LINCOLN PARK PLANNING COMMISSION
CITY HALL – COUNCIL
CHAMBERS 1355 SOUTHFIELD
ROAD LINCOLN PARK, MICHIGAN

Quality Auto Wash
Site Plan Review

Applicant	Odell Lechevalier
Project	Quality Auto Wash
Address	4057 Dix Highway
Date	May 9, 2018
Request	Final Site Plan Review
Recommendation	Approve with Conditions

SOUTH ELEVATION @ $\frac{1}{4}'' = 1'-0''$

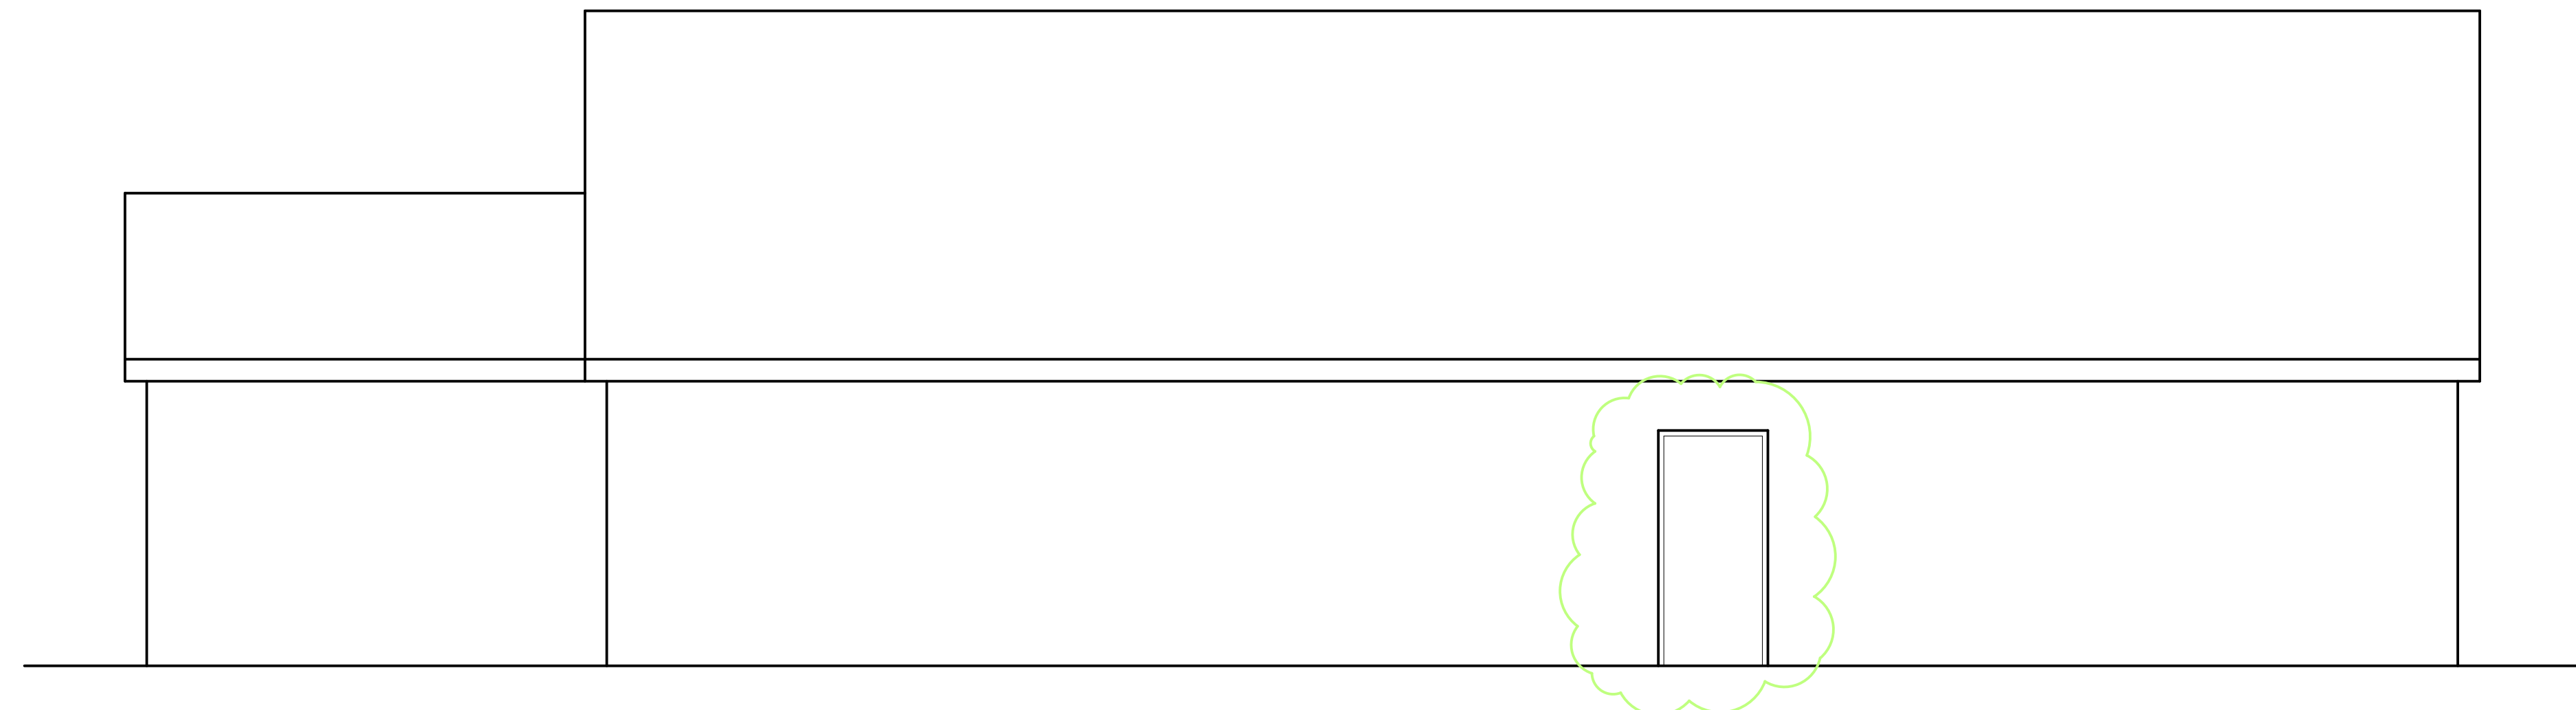
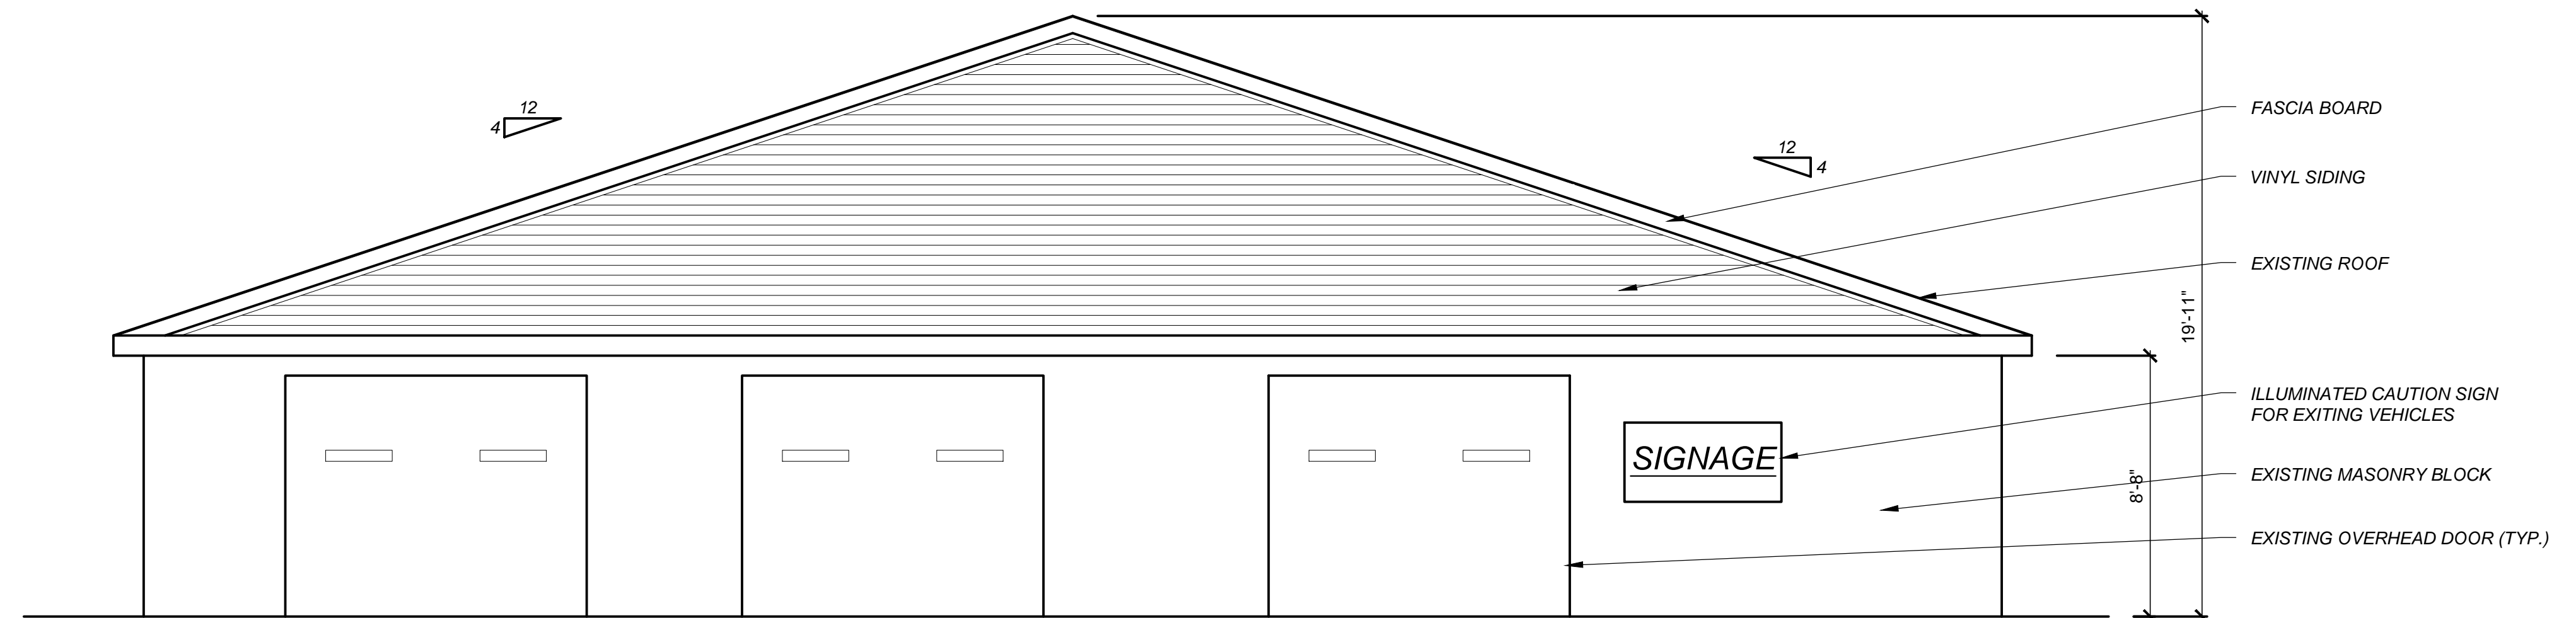
<ul style="list-style-type: none"> • Main entrances: doors larger Applicant to add main entrance door to the building drawn to scale. The east elevation door was added but not drawn to scale. • Framing devices (overhangs, recesses, peaked roof forms, porches, arches, canopies, parapets, awnings, display windows, accent colors, tile work, moldings, pedestrian-scale lighting, distinctive door pulls) 	<p>Substantially met</p>
<ul style="list-style-type: none"> • Pitched / shingled roof forms suggested; overhanging eaves with slope of 0.5 to 1 • Rooflines >100' = roof forms, parapets, cornice lines • Roof-top mechanical equipment screened by roof form. 	<p>Met</p>

- Applicant to add building features and correct height to each elevation drawn to scale.*
